SUBJECT: WOLF CREEK GENERATING STATION - AMENDMENT NO. 51 TO FACILITY  
OPERATING LICENSE NO. NPF-42 (TAC NO. 79923)

WOLF CREEK GENERATING STATION

Amendment No. 51  
License No. NPF-42

RELATED TO AMENDMENT NO. 51 TO FACILITY OPERATING LICENSE NO. NPF-42

FIGURE 2.1-1

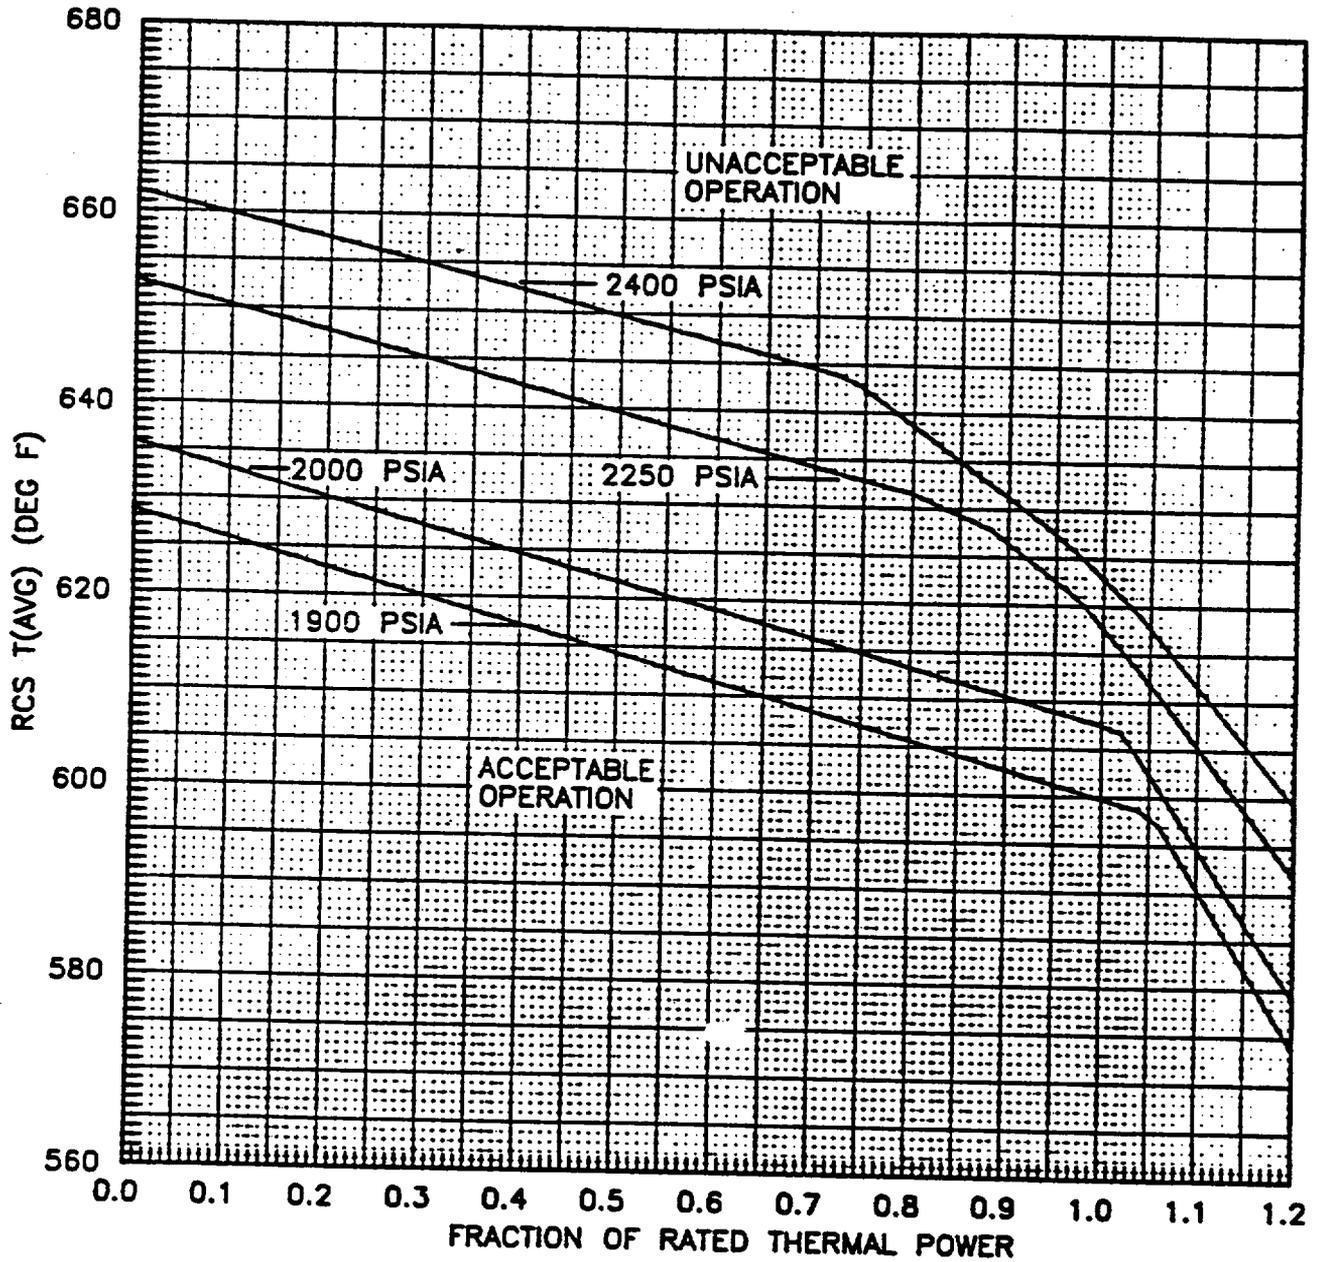
Figure 2.1-2, page 2-2 - "Reactor Core Safety Limit - Four Loops in Operation"

The parameter of pressure in the RCS Tavg versus Fraction of Rated Power curve was redrawn to increase the 1860 psia value to 1900 psia. This was to reflect the modifications in TDF and the CHF correlation and a shift in the steam generator safety valve actuation line. This is acceptable as discussed above in Section 2.0.

FIGURE 3.2-3  
 RCS TOTAL FLOW RATE VERSUS R  
 FOUR LOOPS IN OPERATION

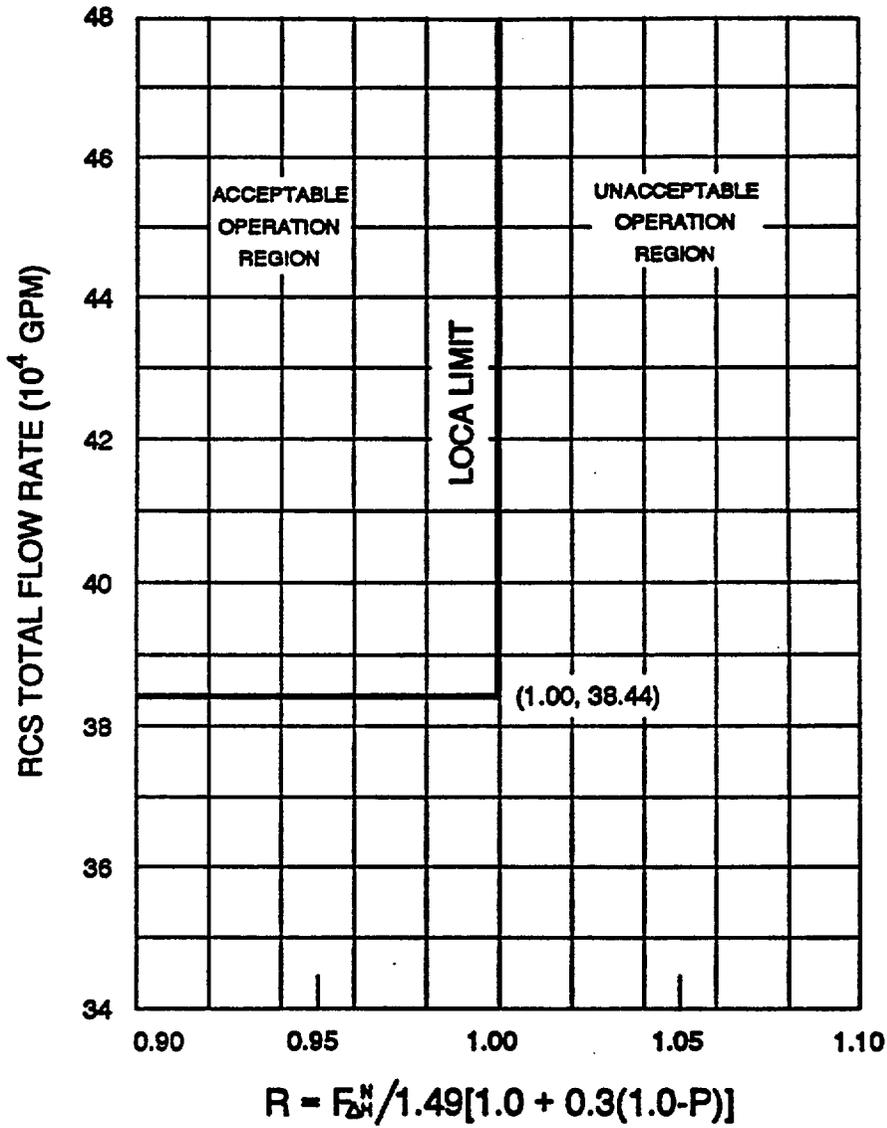
Figure 3.2-3, page 3/4 2-9, - "RCS Total Flow Rate Versus R - Four Loops in Operation"

The total flow rate value of 392,400 gpm was changed to 384,440 gpm. This is acceptable as it is four times the new TDF value of 93,750 gpm/loop and includes the flow measurement uncertainty value of 2.5 percent.
